**TOWN OF MOUNTAIN VILLAGE  
REGULAR DESIGN REVIEW BOARD MEETING  
AGENDA**

**THURSDAY MAY 6, 2021 10:00 AM**

**TO:** Mountain Village Design Review Board  
**FROM:** John Miller, Senior Planner  
**FOR:** Design Review Board Public Hearing; May 6, 2021  
**DATE:** April 26, 2021  
**RE:** Staff Memo – Final Architecture Review Lot 161D-1 Unit 19

**1 SITE SNOWMELT PLAN**  
 S20°37'10"E  
 100.00'

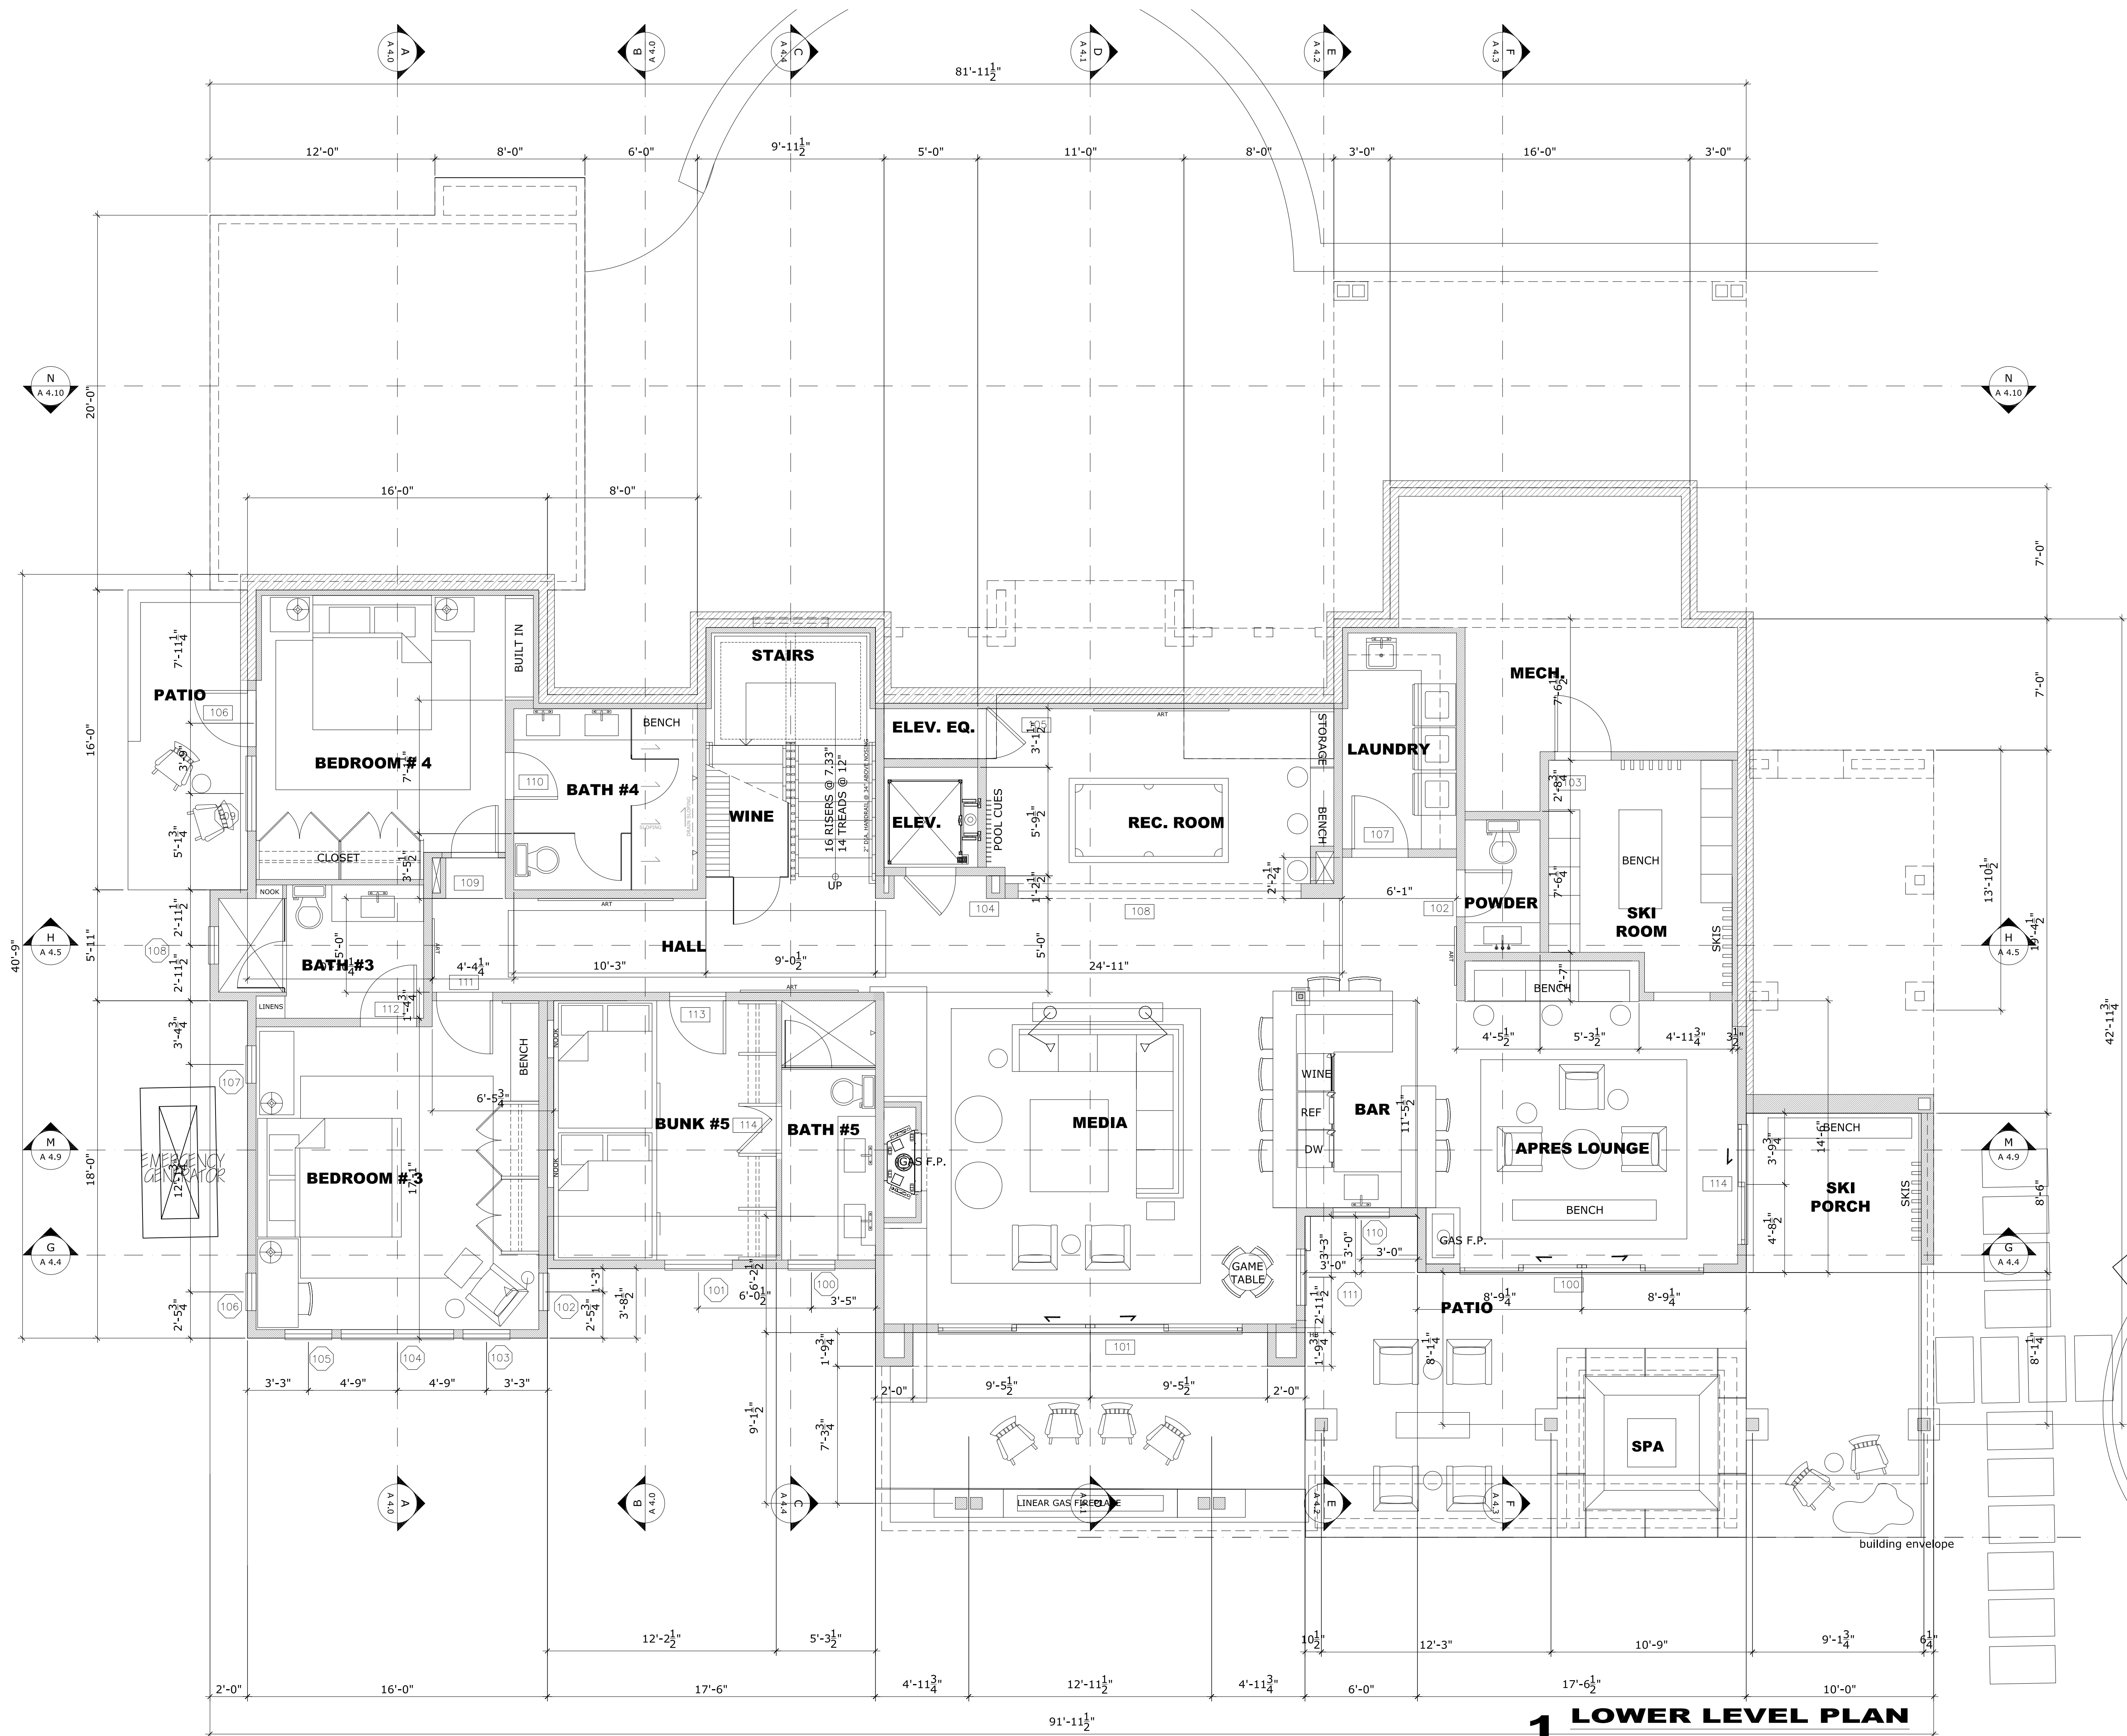
*The applicant has revised the plans since the initial to indicate areas of snowmelt and is currently showing 992 sq ft of snowmelt. The CDC allows for a maximum of 1000 sq ft without penalty.*

**NORTH ELEVATION**  
1/4" = 1'-0"

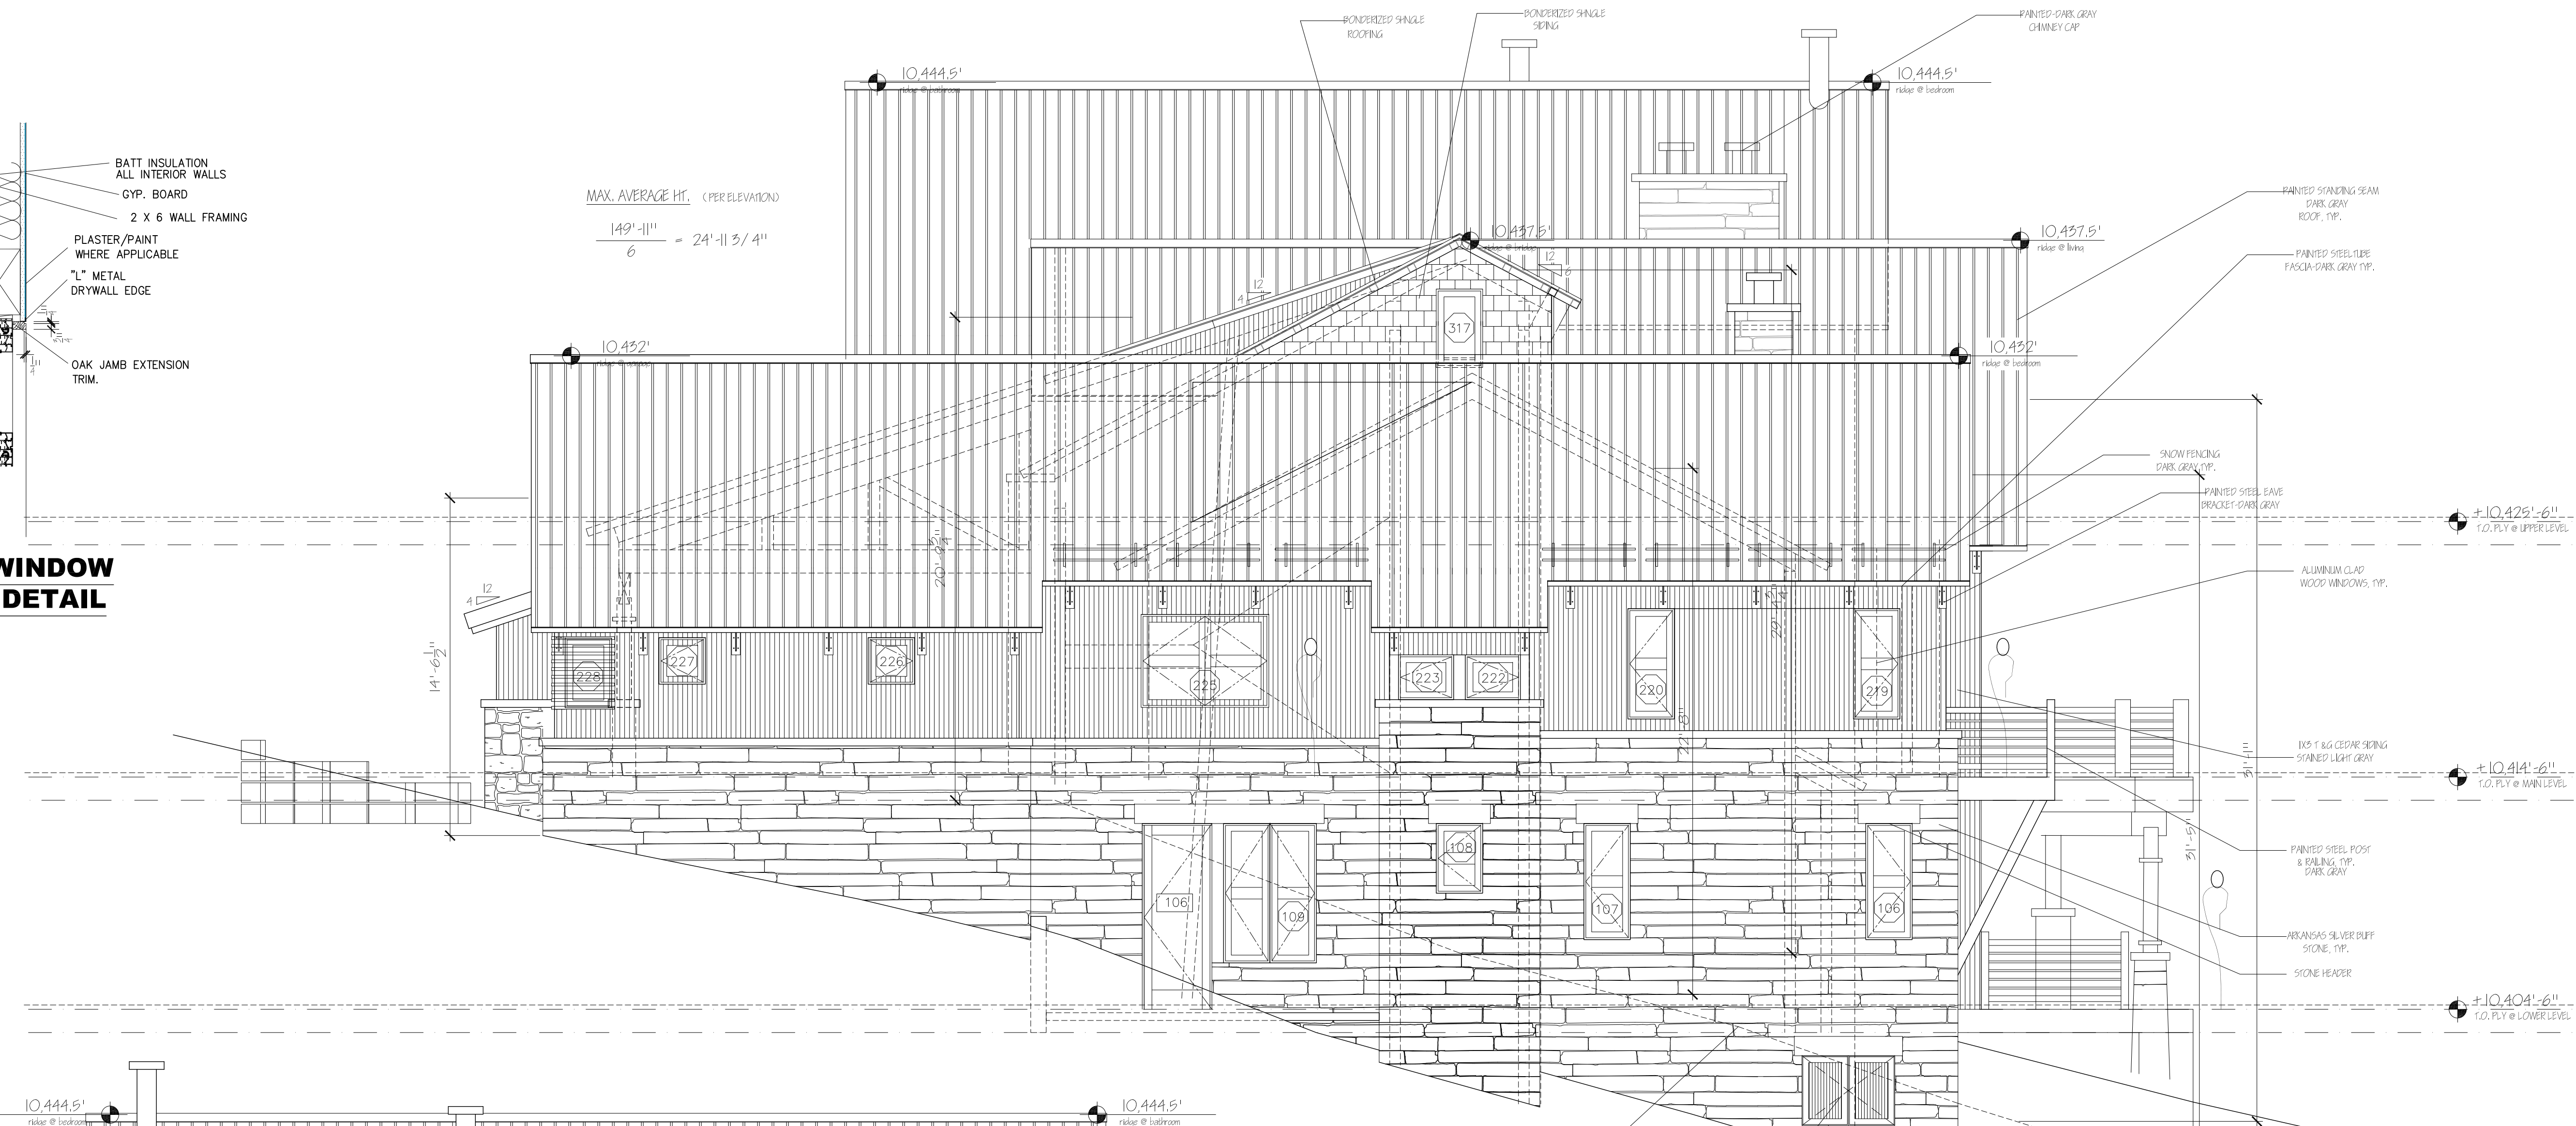
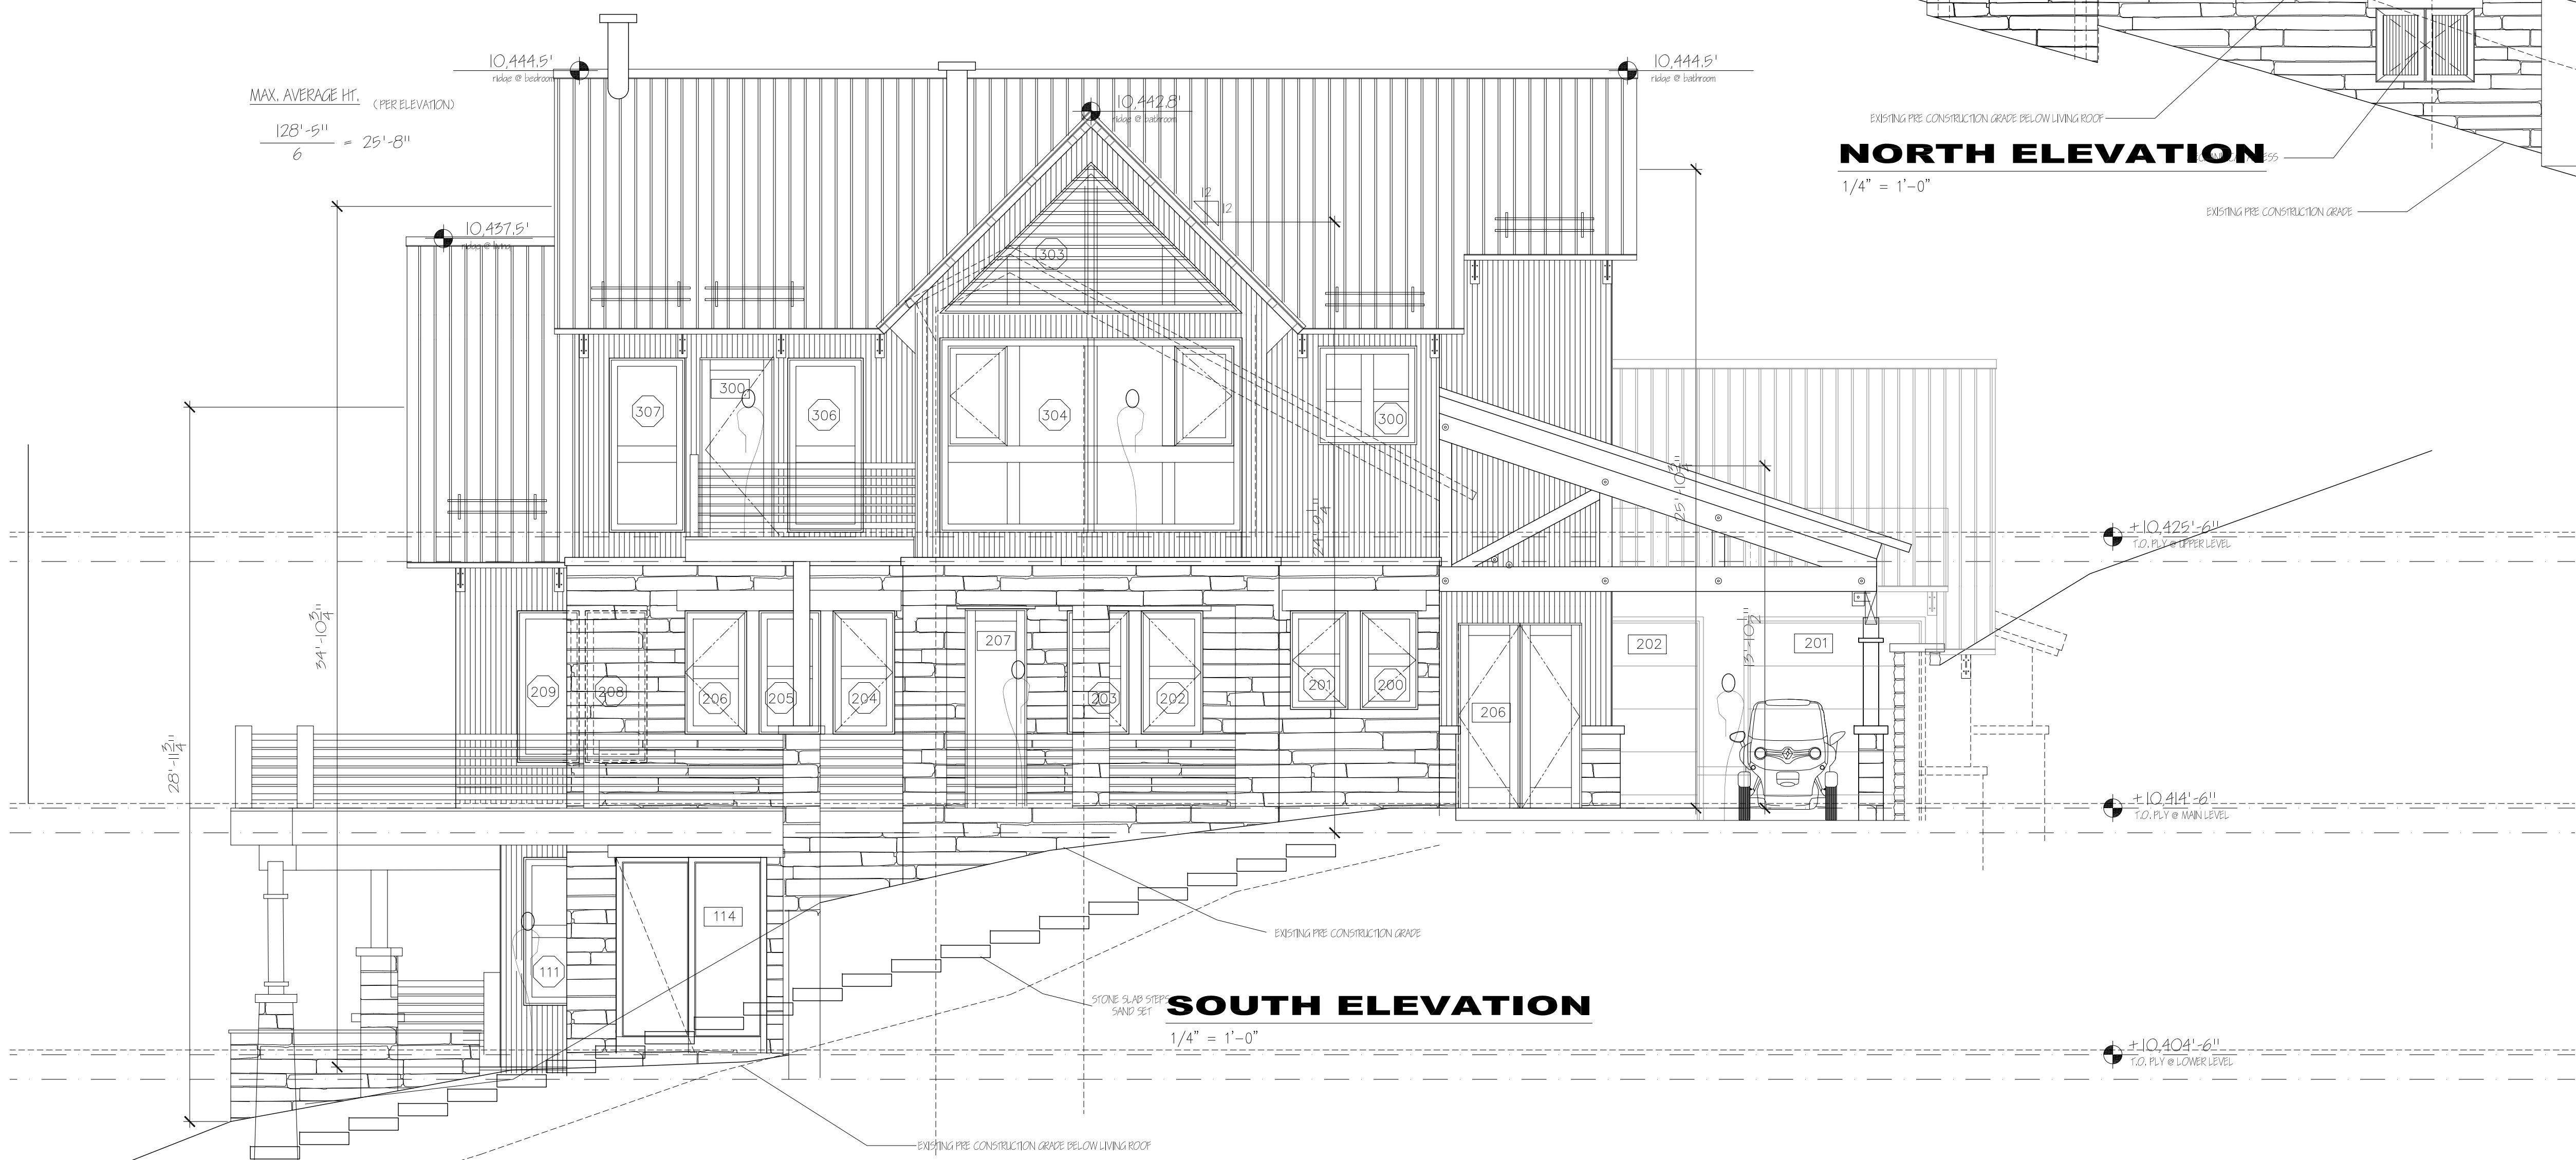
*Staff: The Maximum Building Height and Average Building Height analysis has been provided on pages A3 and A3.1 of the submitted plan set and shown above in Table 1. There have been no changes in height since the Initial Architectural and Site Review (IASR). With a Maximum Height of 40'-6" and a Max Average Height of approximately 25'-0", any approval should condition that a height survey be required prior to the issuance of a framing inspection to determine the heights comply with any DRB approved plan and the development agreement for Coonskin Ridge.*
